RECORD OF DECISION

GRADIENT CONTROL SYSTEM

Twin Cities Army Ammunition Plant

September 1987

figure 6.2  
 CROSS-SECTION - BGRS  
 GROUNDWATER REMEDIATION PROGRAM PLAN  
 Twin Cities Army Ammunition Plant

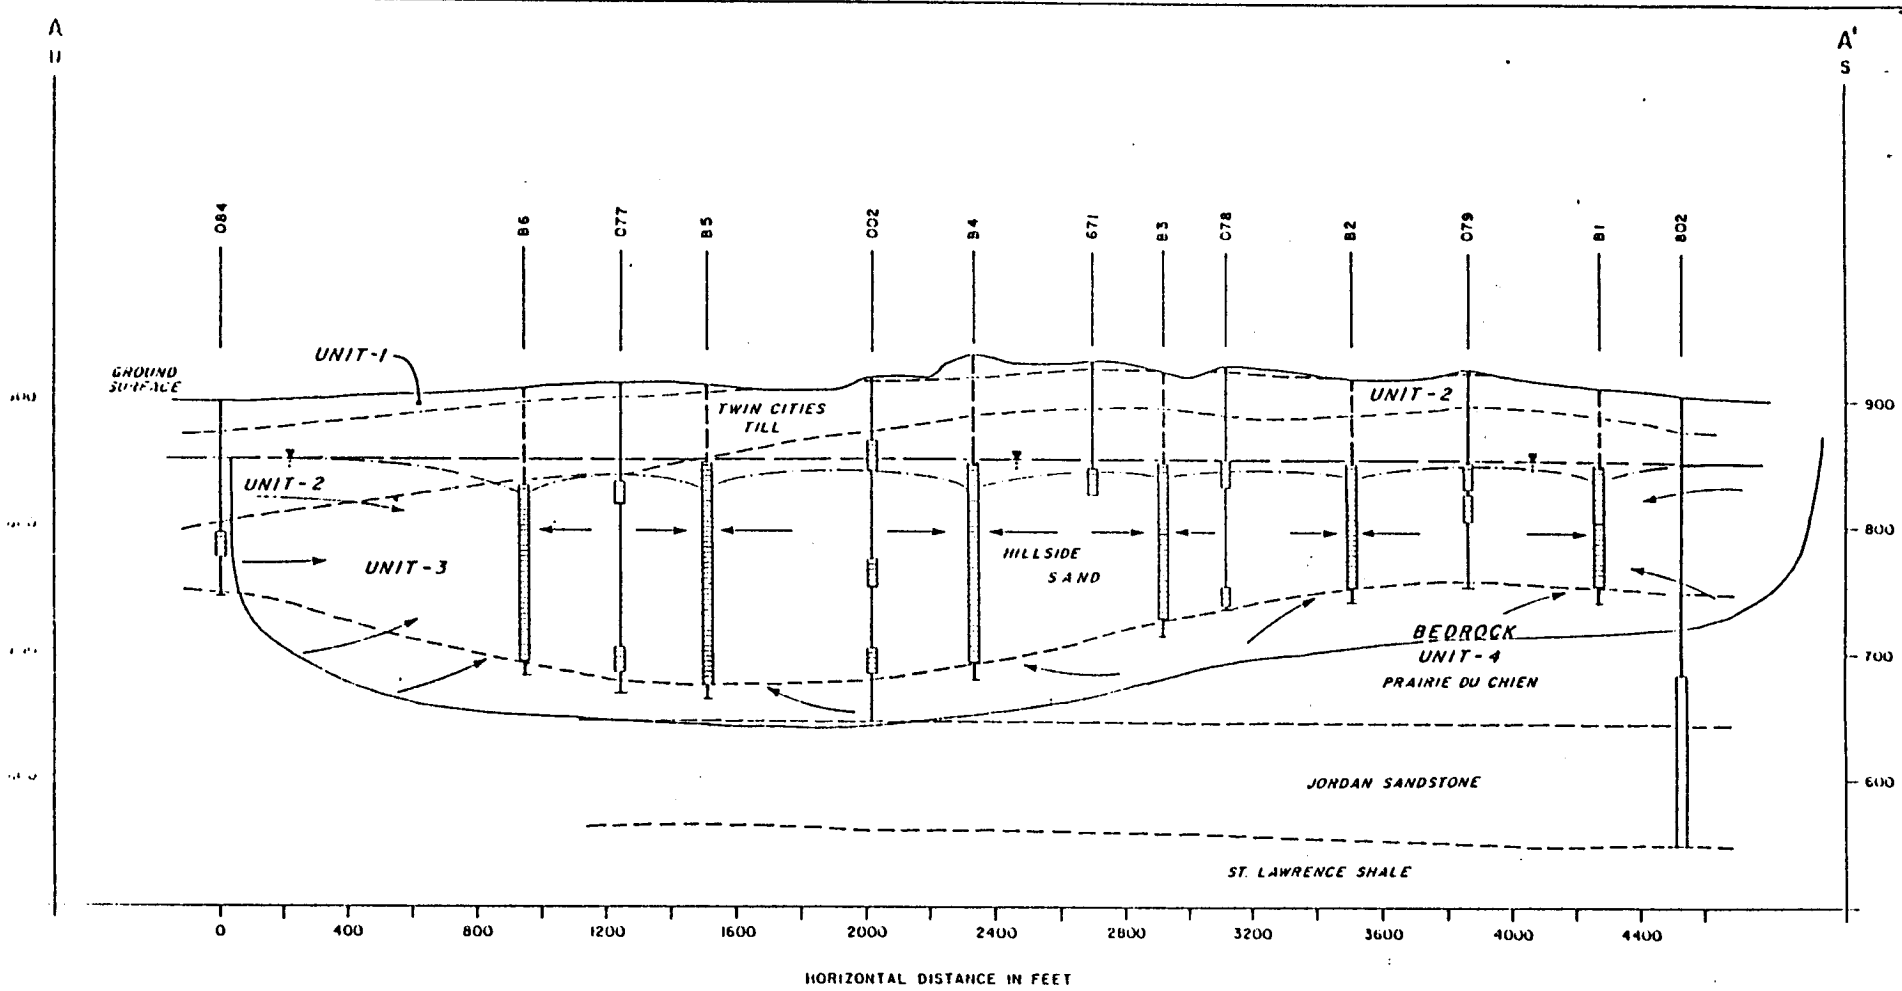
- 3) Bruce A. Liesch commented that the U.S. Army proposed to determine the need for bedrock recovery wells along the southwest TCAAP border based on the drawdown influences in the bedrock from BGRS pumping. To do this a series of well nests would need to be present to determine the hydraulic response in the upper, middle and lower units of both bedrock aquifers. This is needed to observe how deep the hydraulic response from the BGRS system operation propagates. The City of St. Anthony adds that it is unclear whether removal of contaminated water from deeper aquifers and upward draw can be accomplished through the BGRS, and, further there is no means to verify whether this is taking place.

U.S. EPA Response: The existing monitoring network is adequate to demonstrate if adequate upward draw from bedrock exists. U.S. EPA expects that the first 90 days of operation and data collection will demonstrate that modifications will be needed (e.g., if bedrock extraction wells need to be constructed and operated).
